Technical Service Information

THM 4T60-E REVISED BOTTOM PAN OIL SCOOP

Figure 1

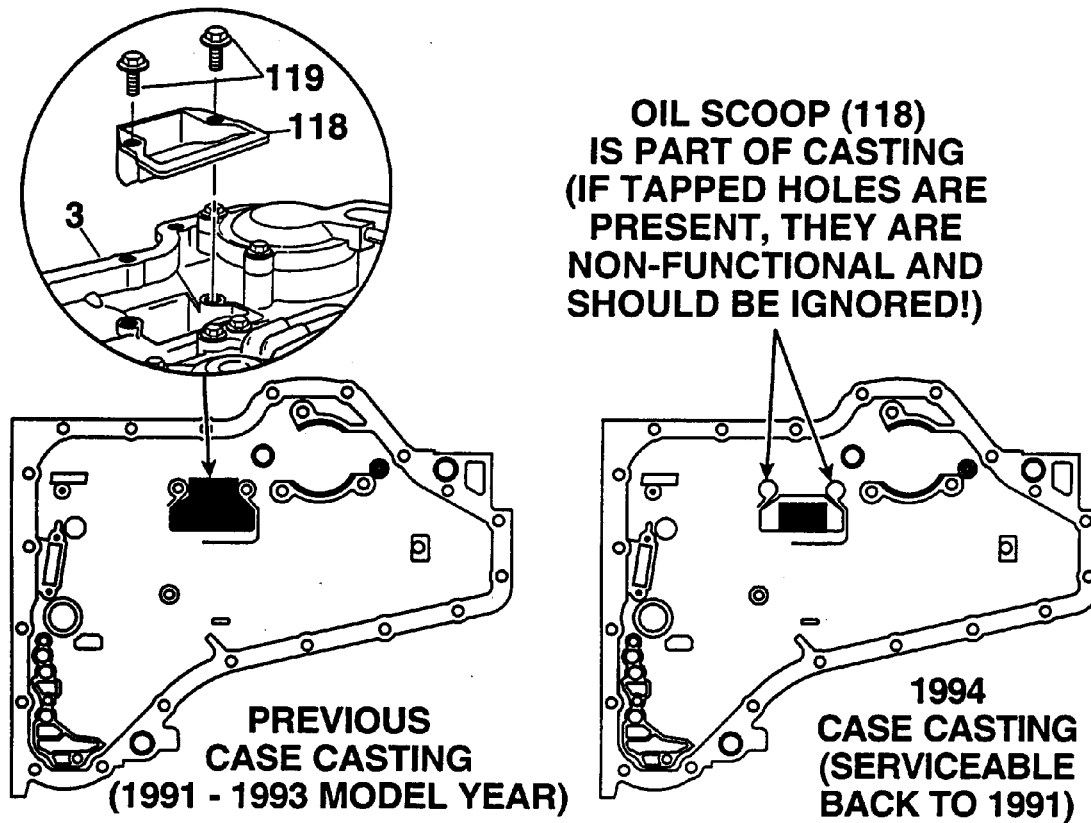
CHANGE: Beginning at the start of production 1994, all TBM 4T60-E transaxle cases have the bottom pan oil scoop cast into the transaxle case, eliminating the need for the previous plastic oil scoop held in place with the two retaining bolts (See Figure 1).

(1) TRANSAXLE CASE - Now has the bottom pan oil scoop cast into the transaxle case, as shown in Figure 1.

(2) PLASTIC BOTTOM PAN OIL SCOOP - Eliminated, along with the two retaining bolts, as shown in Figure 1.

The 1994 transaxle case will back service all previous model 4T60-E transaxles, and the plastic oil scoop and retaining bolts should be discarded.

NOTE: Some 1994 cases may have been drilled and tapped where the oil scoop bolted in previously. These tapped holes are nonfunctional and should be ignored.
